UNITED STATES PATENT AND TRADEMARK OFFICE

APPLICATION NO.	FILING DATE	FIRST NAMED INVENTOR	ATTORNEY DOCKET NO.	CONFIRMATION NO.
09/541,765	04/03/2000	Mareike Klee	PHD 99.046	4722

Office Action Summary

DETAILED ACTION

FIG. 1

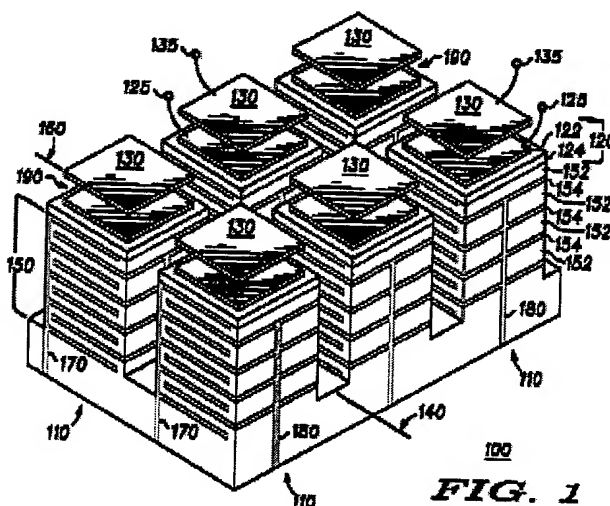
Regarding claims 1, & 10, Malone et al. disclose in fig. 1, a ceramic passive component (100) comprising a carrier substrate (col. 9 lines 40-45, col. 1 lines 35-37); one first electrode (154) formed of a metal and having a first surface disposed on the substrate, a dielectric (152) having a first surface disposed, on a second surface of the

first electrode opposing the first surface of the first electrode and a second electrode (154, 122 & col. 2 lines 39-48), disposed on a second surface of the dielectric opposing the first surface of the dielectric, wherein the dielectric is a ferroelectric ceramic with a voltage-dependent relative dielectric constant (see abstract materials). (Regarding claim 10, the ceramic passive component can be used in a filter (col. 1 lines 30-40)).

Regarding claim 3, Malone et al. disclose the second electrode (152, 122 & col. 2 lines 39-48) discloses first (152) and second (122 (without 124 –see col. 2 lines 39-48)).

Regarding claim 5, Malone et al. disclose the second electrically conducting layer (122) comprises a metal.

Regarding claim 12, Malone et al. disclose a use of a ceramic passive component (100) which comprises: a carrier substrate, a first electrode (154) comprising a metal having a first surface disposed on a substrate, a dielectric layer (152) having a first surface disposed on a second surface of the first electrode, a second electrode (154) disposed on a second surface of the dielectric layer, and said dielectric comprises a ferroelectric ceramic material with a voltage dependent relative dielectric constant (see abstract & col. 3 lines 28-36).
